Product Change Notification / LIAL-10HDQI000

CCB 3104.005 Final Notice: Qualification of MPHL as a new final test site for selected ATMEGA48xx, ATMEGA88xx and ATMEGA168xx device families available in 32L TQFP (7x7x1mm) package.

PCN #: LIAL-10HDQI000

CCB 3104.005
Pre and Post Change Summary
PCN#: LIAL-10HDQI000

Tape and Reel - Carrier Tape

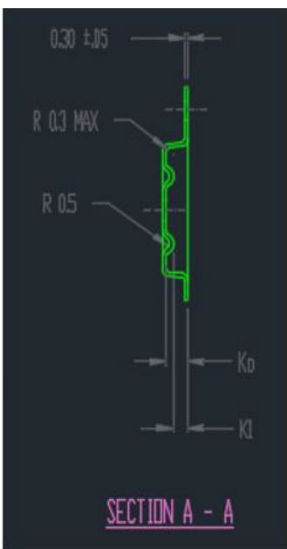
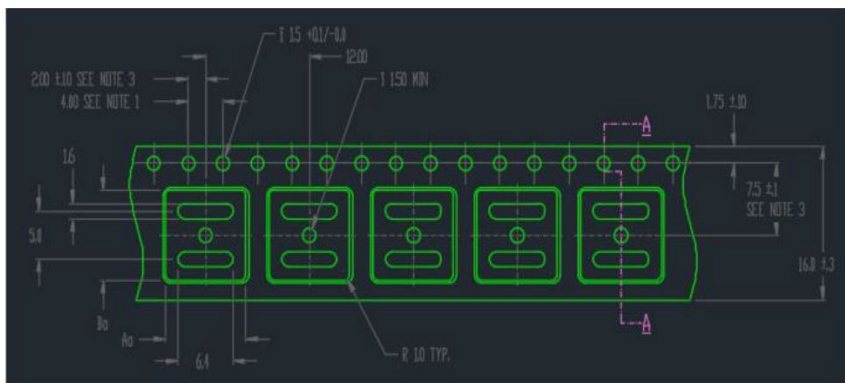
ANAP

NOTES:
 1. 10 SPROCKET HOLE PITCH CUMULATIVE TOLERANCE ±0.2
 2. CAMBER IN COMPLIANCE WITH EIA 481
 3. POCKET POSITION RELATIVE TO SPROCKET HOLE MEASURED AS TRUE POSITION OF POCKET, NOT POCKET HOLE

W	P	Ao	Bo	Ko	K1
16.00 (+/- 0.30)	12.00 (+/- 0.10)	9.30 (+/- 0.10)	9.30 (+/- 0.10)	1.80 (+/- 0.10)	1.20 (+/- 0.10)

Thickness	Color
0.30 (+/- 0.05)	Black

MPHL

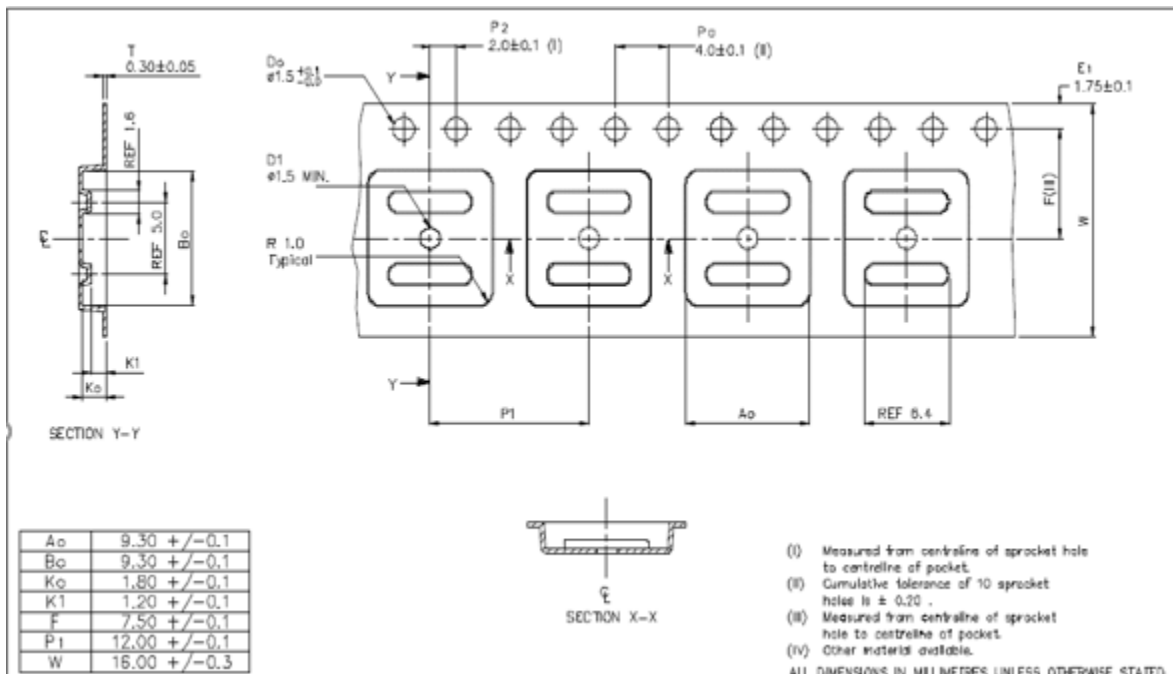
W: 16 mm
 P1: 12 mm
 A0: 9.30 mm
 B0: 9.30 mm
 K0: 1.80 mm
 K1: 1.20 mm

ANAP

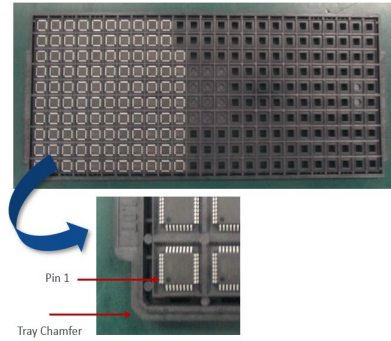
ANAP	MPHL
Base Quantity Multiple (BQM)	250	250
Pin 1 orientation	Pin1 near Tray Chamfer	Pin1 near Tray Chamfer
